STATE OF MAINE
DEPARTMENT OF TRANSPORTATION
16 STATE HOUSE STATION
AUGUSTA, MAINE 04333-0016

July 1, 2022
Subject: Matinicus Island Ferry
Replacement
State WIN: 024897.10
Location: **Rockland**
Amendment No. 4

| 1 | CORRECTION TO LINEWEIGHT-REPLLOT | 6/29/22 | KVC |
|--|----------------------------------|---|------------|
| DWG. NO. | D367-P7-1 | ALT. | 1 |

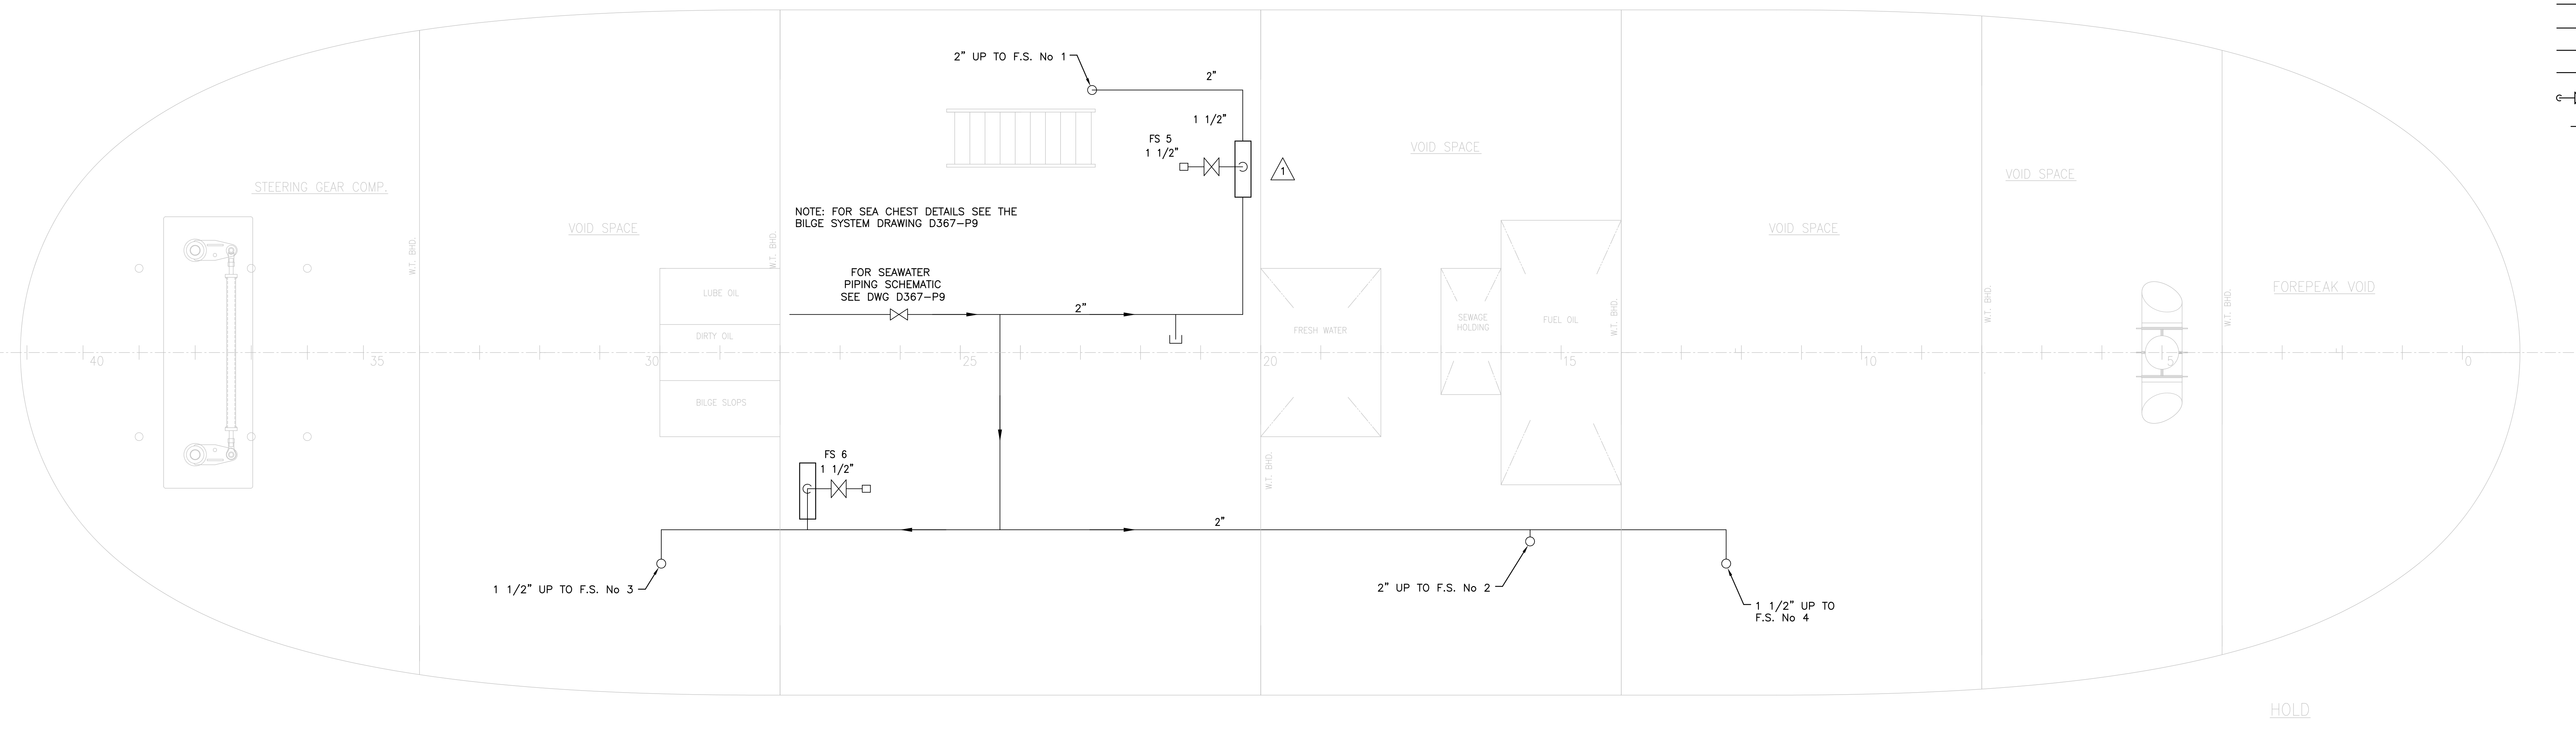
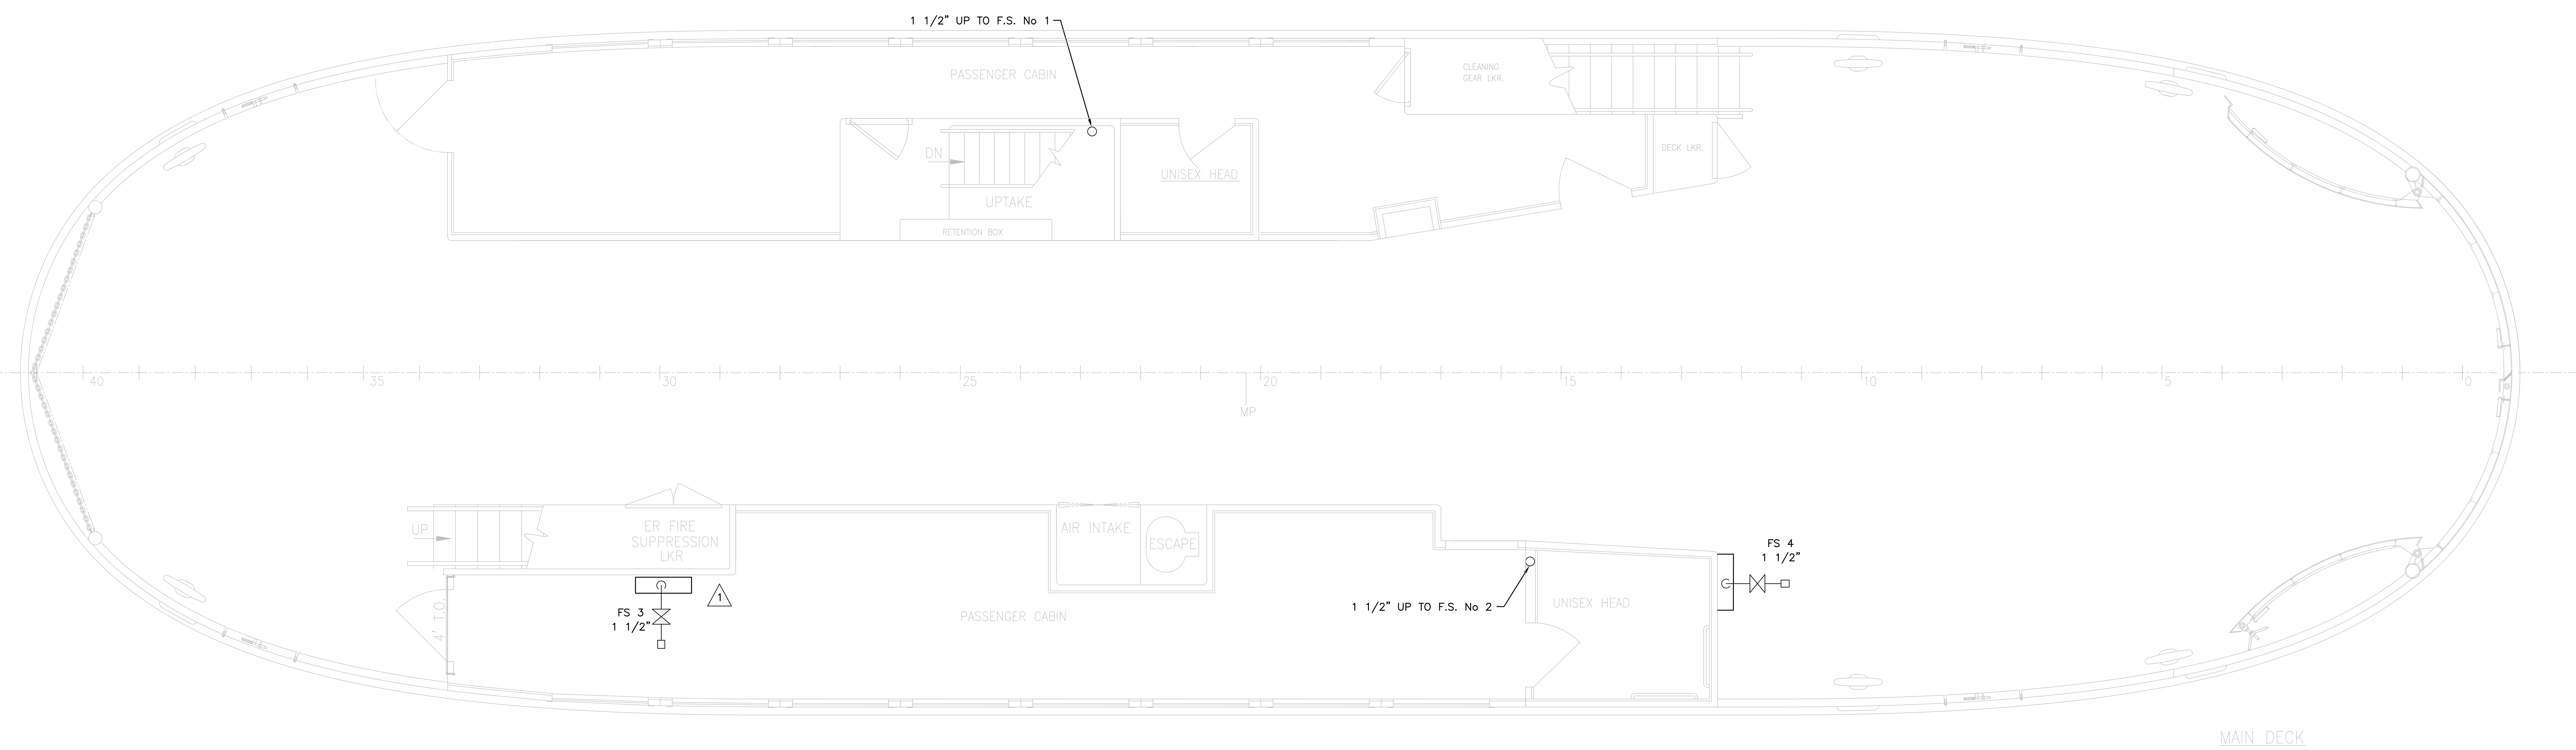
Question: Please confirm quantity of fire stations. The Drawing shows 4, while the specification discusses 6 locations.

| 1 | CORRECTION TO LINEWEIGHT-REPLLOT | 6/29/22 | KVC |

Response: Fire station quantity shall be as shown on Plans D367-P7-1 and D367-P7-2 as discussed in next paragraph. There are 4 fire stations shown on plan D367-P7-1 and 2 fire stations shown on plan D367-P7-2. Specifications, in Section 521.1.1, page 69 of 108 list 6 fire stations. Also see next paragraph regarding change to number of fire hoses and nozzles in Bill of Material on plan D367-P7-2.

| 1 | CORRECTION TO BOM QTY | 6/29/22 | KVC |
|--|-----------------------|---|------------|
| DWG. NO. | D367-P7-2 | ALT. | 1 |

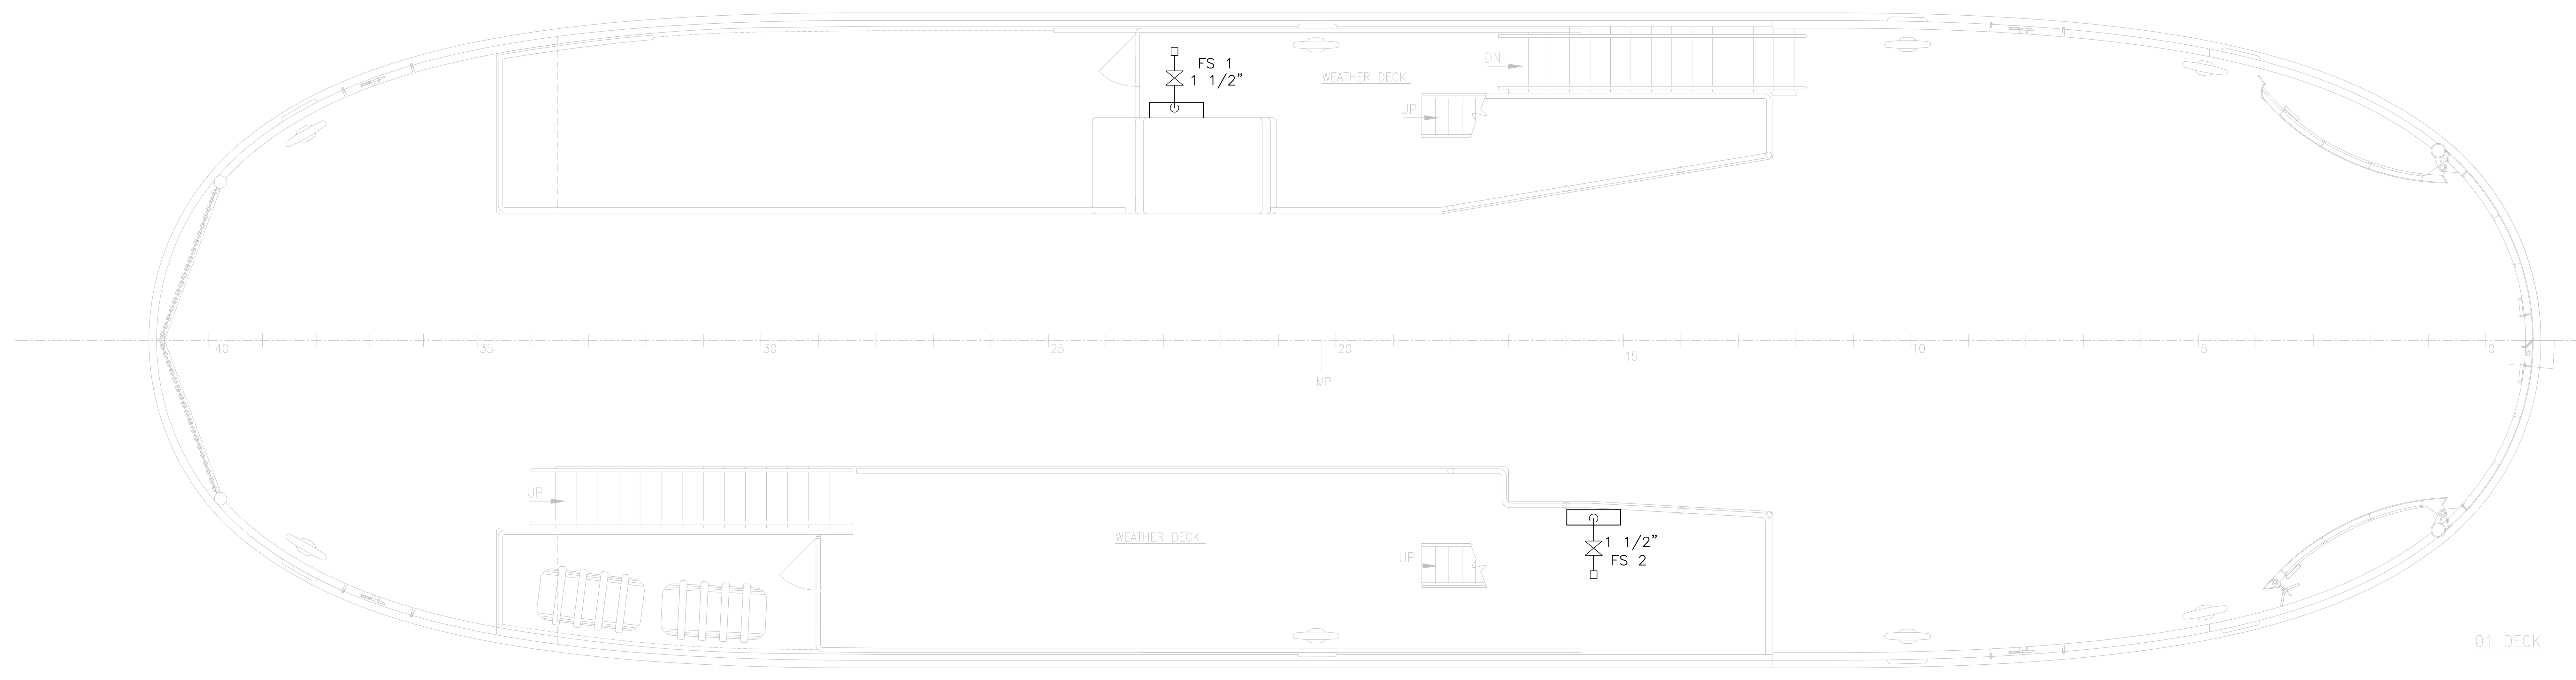
| 1 | CORRECTION TO BOM QTY | 6/29/22 | KVC |
